RE: 12th Street Road Diet (CPN 718780)
Preliminary Drainage Report
Engineer's Stamp Date: No Date
Hydrology File: H13D120

Based upon the information provided in your submittal received 03/12/2024, the Final Drainage Report **is not** approved for Work Order. The following comments need to be addressed for approval of the above referenced project:

12TH STREET ROAD DIET
FROM SAWMILL ROAD TO RAILROAD SPUR
City Project No. 718780
PRELIMINARY DRAINAGE REPORT

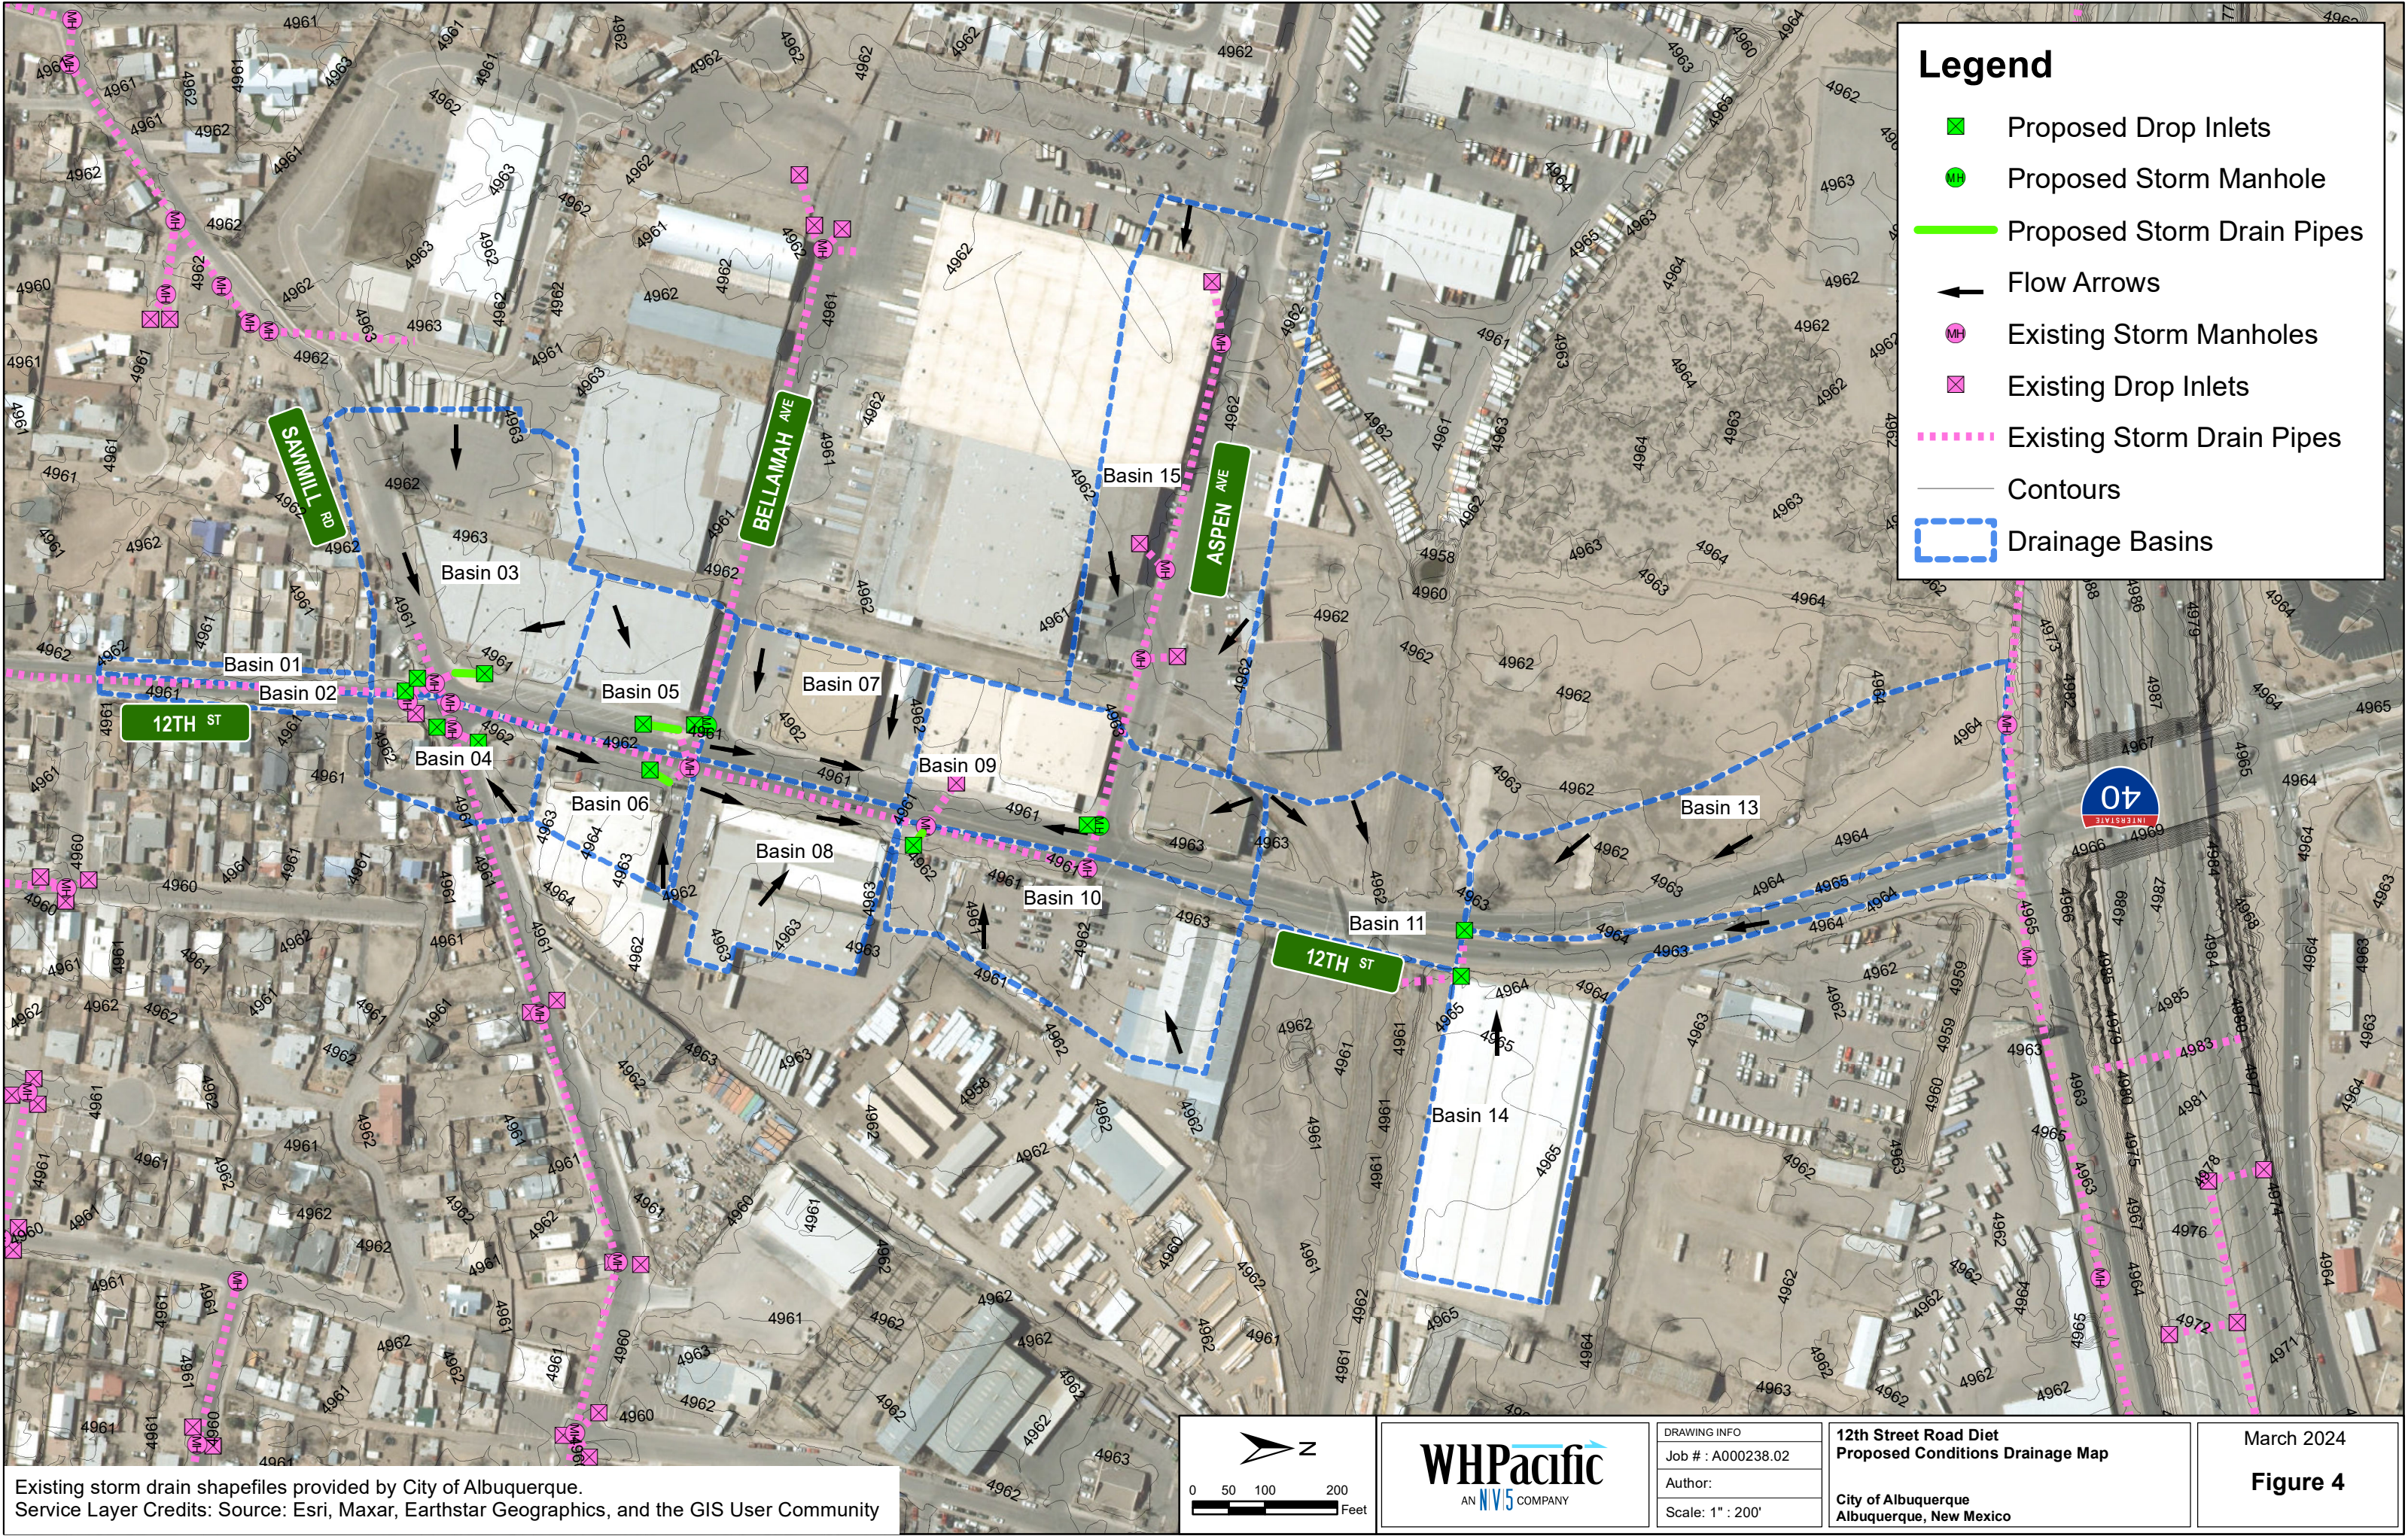
1. Please provide an engineer's stamp with a signature and date.
2. It appears that the drainage area for Bellamah Ave is missing in both the existing conditions and proposed conditions drainage maps.
